RE: **Heritage Marketplace Tract A2 (Burger King)**  
**7900 Ladera Dr NW**  
**Request for Certificate of Occupancy – Temporary**  
**Hydrology Inspection - Approved**  
**Revised Grading Plan Stamp Date 12/18/18 (File: H09D024A)**  
**Certification Dated: 12/22/18**

## DRAINAGE AND TRANSPORTATION INFORMATION SHEET (REV 6/2018)

ENGINEER'S SEAL	Title: BURGER KING 7900 LADERA DRIVE NW GRADING AND DRAINAGE PLAN REVISED APPROVED PLAN FOR ADMINISTRATIVE AMEND	DRAWN BY DATE
	RHD Engineering, LLC 4305 Purple Sage Ave. NW ALBUQUERQUE, NM 87120 (505) 288-1621	SHEET # 1 of 2
3/08/18 12/18/18	Richard Dourte P.E. #10854	JOB #

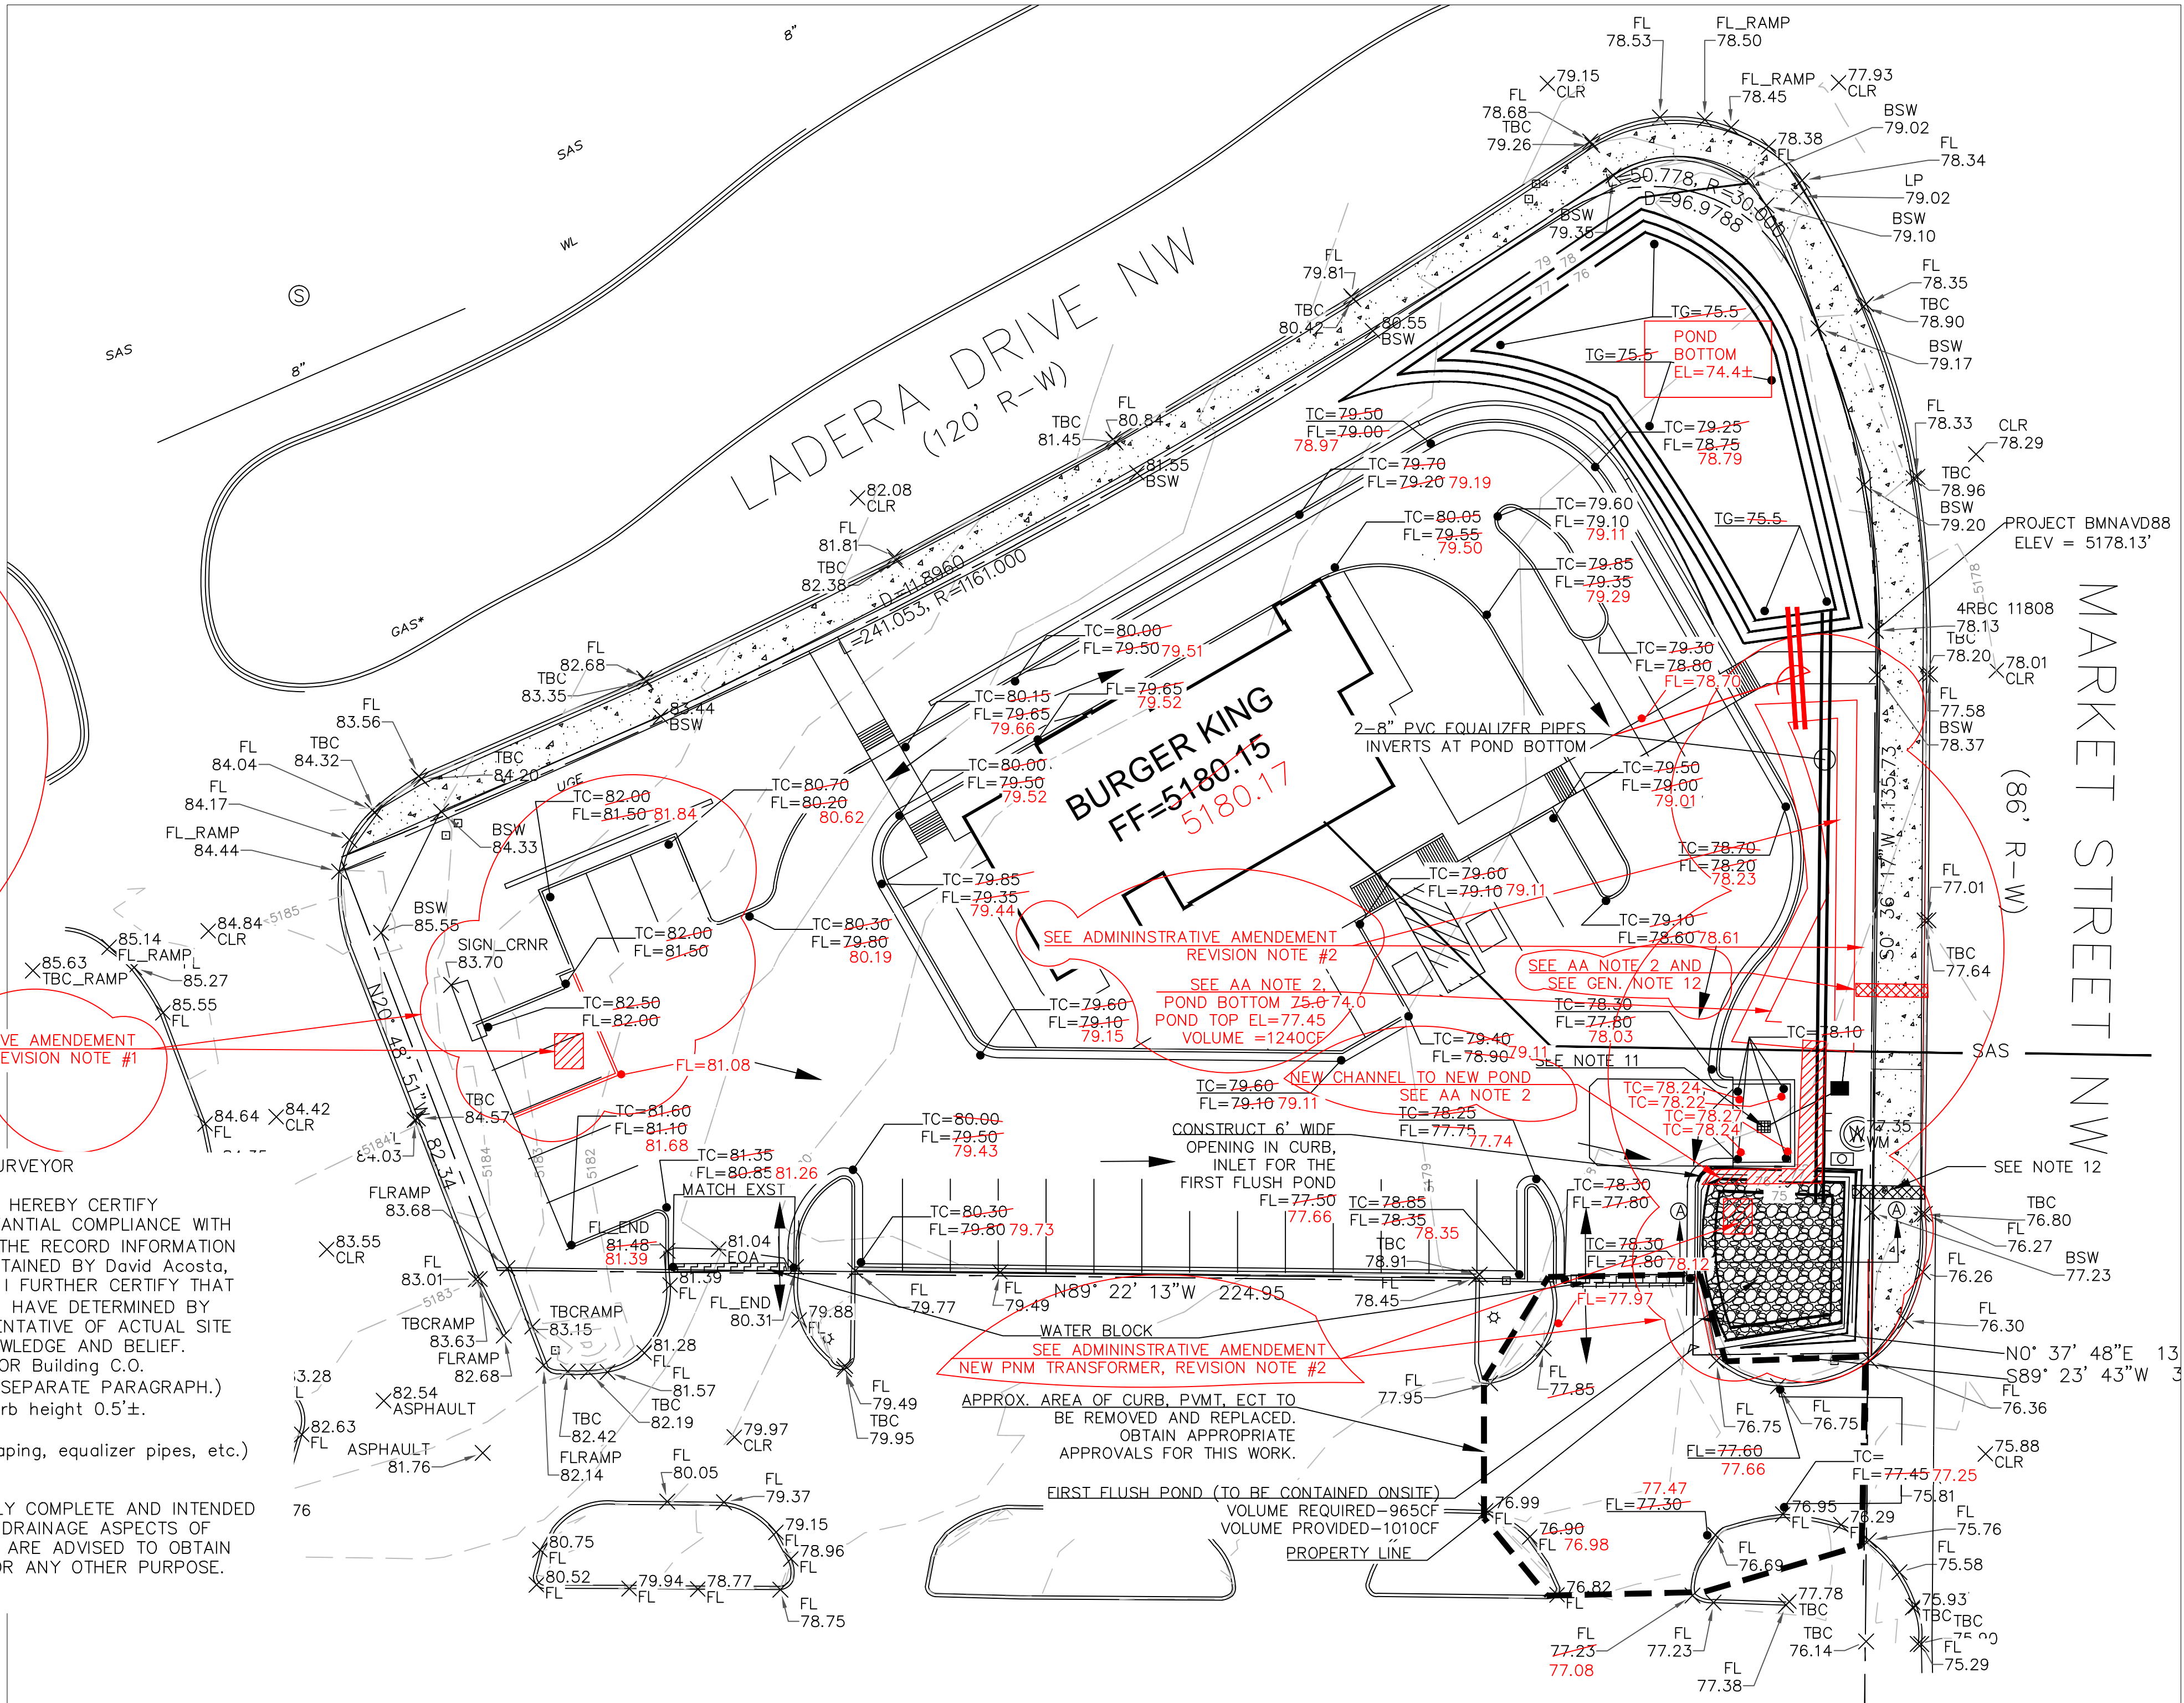
Based on the submittal received on 12/24/18, this certification is approved in support of Temporary Certificate of Occupancy by Hydrology.

1. All pond appurtenances (sidewalk culverts, slope protection, landscaping, equalizer pipes, etc.) need to be completed.
2. The sidewalk culverts must be inspected and approved by storm drain maintenance (Jason Rodriguez, jtrodriguez@cabq.gov or 857-8607).
3. The Drainage Covenant must be recorded with Bernalillo County and a copy included with the drainage certification.
